Groundwater & Wastewater Services
Septic Project File & Data Review Worksheet

GWS File #: 67923 WASPS App #: 1415

RE: Request for an Improvement Permit for Lot 54 off of Sample Road.
MCHD File #6792B

Design Specifications for Lot 54 off of Sample Rd.
MCHD File # 6792B

Scale: 1 inch equals 50 feet	S&ME	Faison - Sample Road LLC	FIGURE
Drawn by: JBP		Lot 54	1
Reviewed by: TCJ		Mecklenburg County, NC	
Date: June, 2007	ENVIRONMENTAL SERVICES • ENGINEERING • TESTING	S&ME Project #1588-05-091

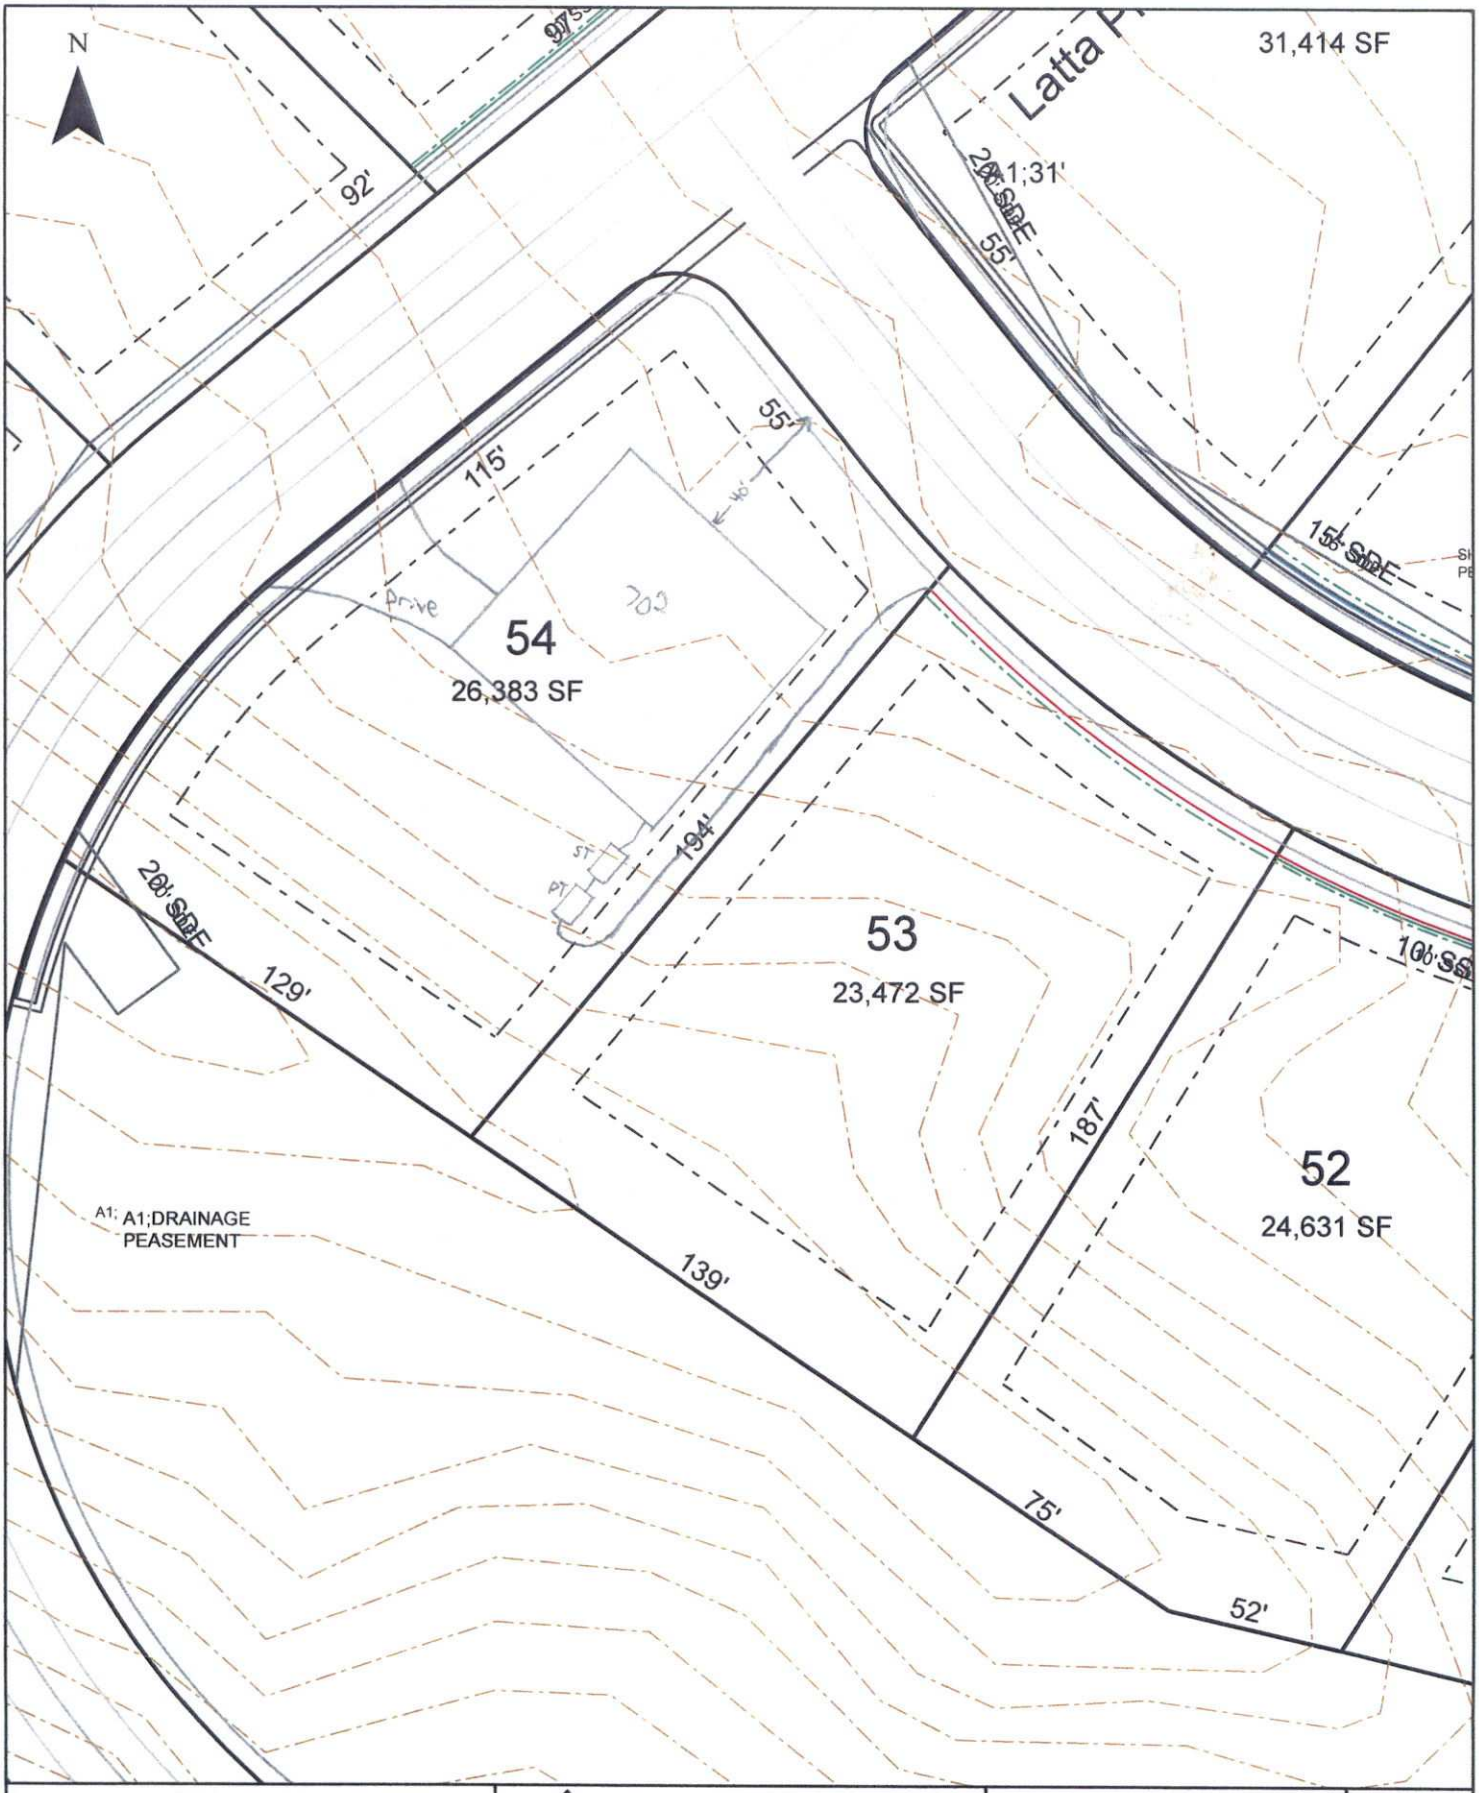
Please review the attached system sketch and design specifications for the Improvement Permit. If necessary, the MCHD may add comments to the site plan or specifications. Please call if you have any questions or comments.

Approved	Disapproved
GWS File #: 6792B		
Design Review: TCT 7-23-07	☒	☐
Field Review: 7/24/07	☒	☐

ENCASEMENT PIPE DETAIL

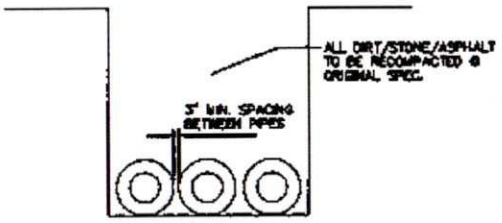
Mr. Fox-
Retreat at Latta specifically. I know NCDOT is much more reasonable, so I was wondering if we could do something a little less than welded steel pipe that may actually last longer. Welded Steel piping painted is $150K more than ductile iron with slip joints and tracer wires, and I cannot imagine there is a structural difference to the roadway. I would really like some help with that if you can.

Mr. Fox-
I was wondering if there is an alternate to the standard crossing detail or if we could propose an alternate to the welded steel pipe required by Huntersville. This is an extremely expensive option, and we would like to propose using ductile iron pipe with slip joints and different color tracer wires. We would still as-built everything the same, but the cost savings is tremendous, and the different color tracer wires would last longer than paint. Can you approve or is there someone else I'd need to go through?
Thanks,
Tom

Upon your request, you may use slip joint ductile iron encasement pipe in lieu of the welded steel pipe as indicated on the Encasement Detail for the low pressure sewer crossings at the Retreat at Latta. This change is being made due to the fact that ductile iron will provide adequate strength for the crossing as well as provide water tight seals at the joints. Please note however, this is the only change being made to that detail. Specified lengths, depths, and sizes shall still be in compliance with the detail.
